**National Committee on Uniform Traffic Control Devices  
TECHNICAL COMMITTEE RECOMMENDATION TO SPONSORS**

**TOPIC: Horizontal Alignment and Advisory Speed Warning Signs**

**AFFECTED PORTIONS OF MUTCD: Sections 2C.06 Thru 2C.11, 2C.36 and 2C.46;  
Table 2C-5; Figures 2C-1, 2C-5 and 2C-7**

Revised Figure 2C-5. Speed Reduction Signs

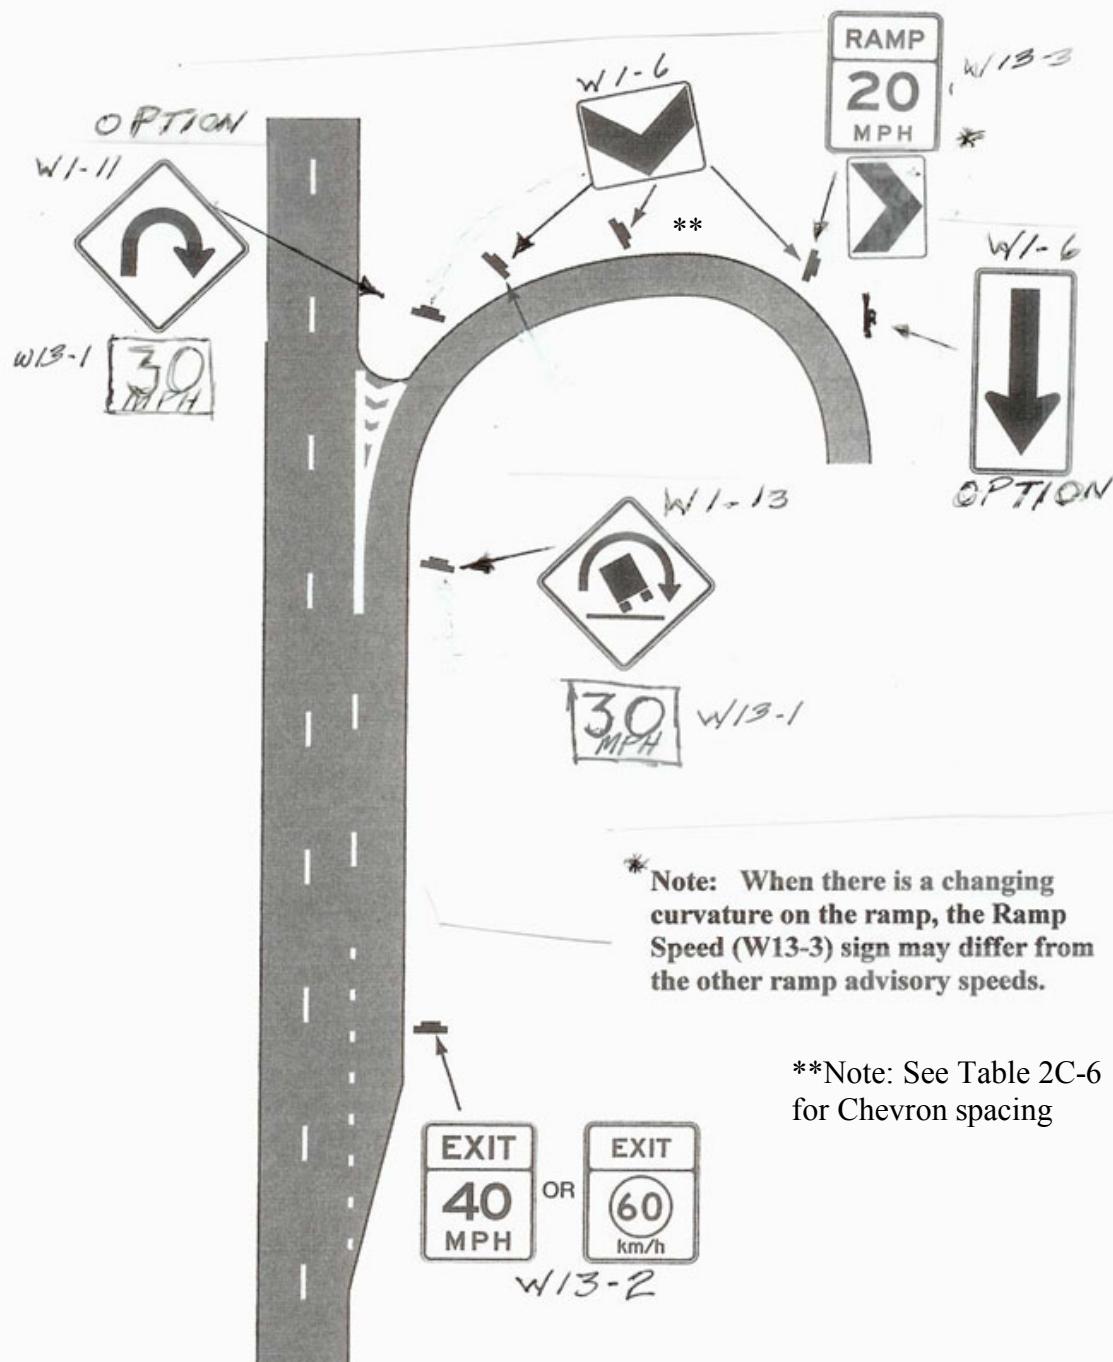
Revise Figure 2C-5, ~~Advisory Speed and~~ Speed Reduction Signs, by relocating the Advisory Speed signs to Figure 2C-1. Note that the Advisory Curve Speed (W13-5) sign has been deleted.

Revised Figure 2C-7. Example of Advisory Speed Signing for an Exit Ramp

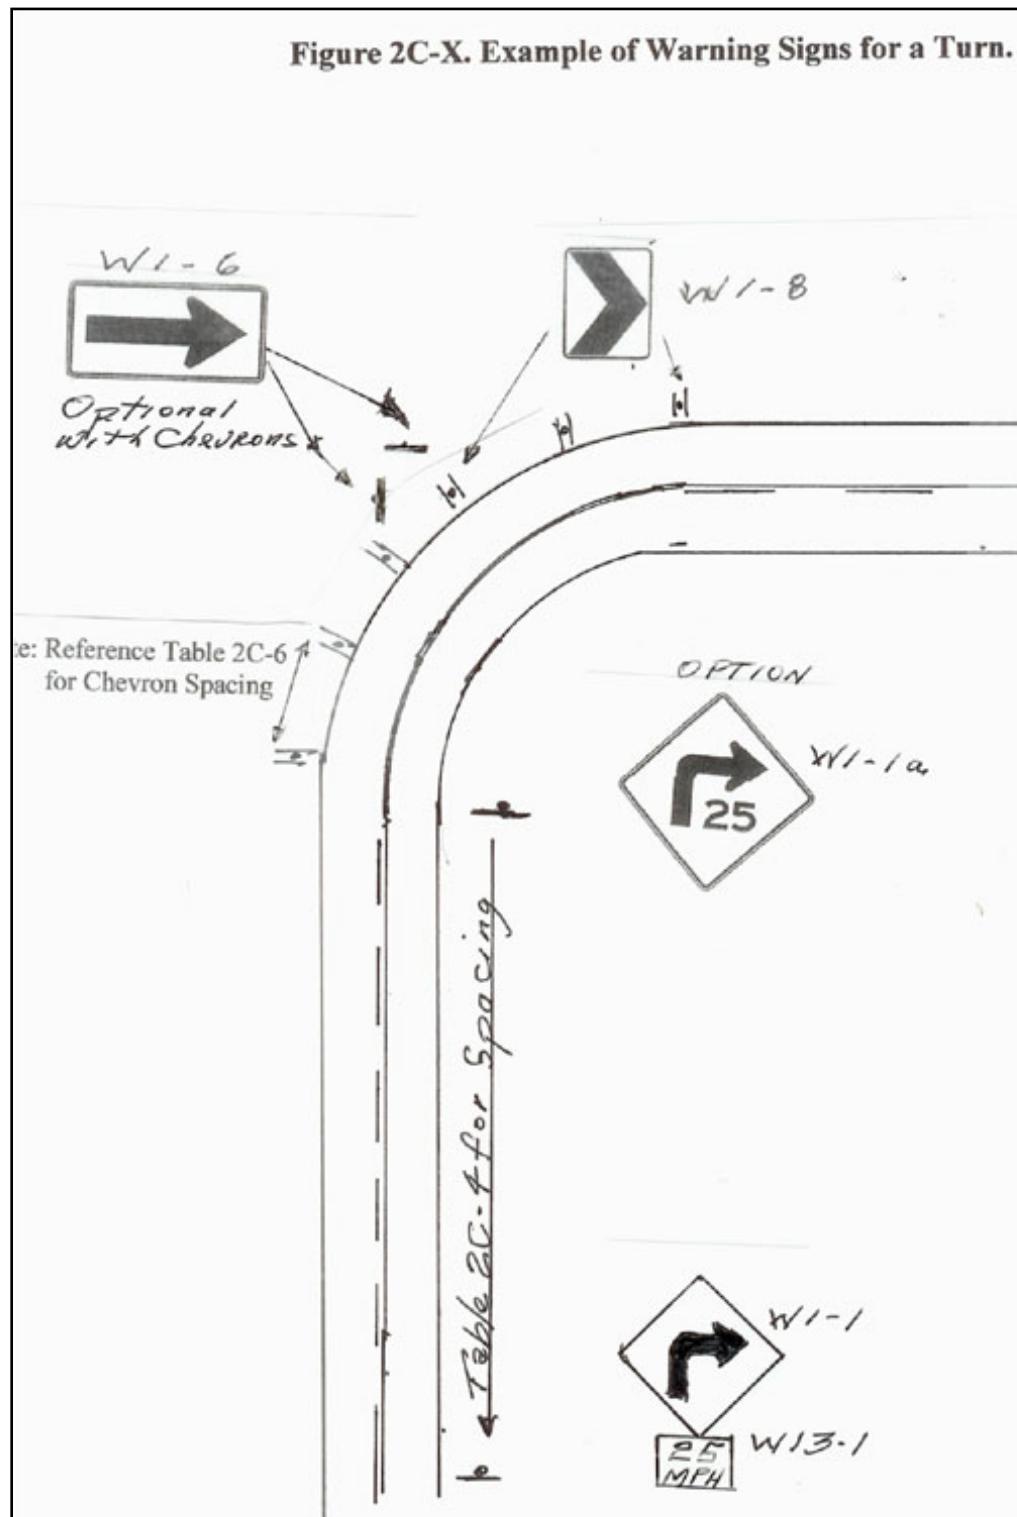
Figure 2C-7 has been revised to provide a better example of Exit Speed, Ramp Speed and Truck Rollover Warning signs.

Revise Figure 2C-7. Example of Advisory Speed Signing for an Exit Ramp, to illustrate the signing addressed in Section 2C.13 and 2C.14.
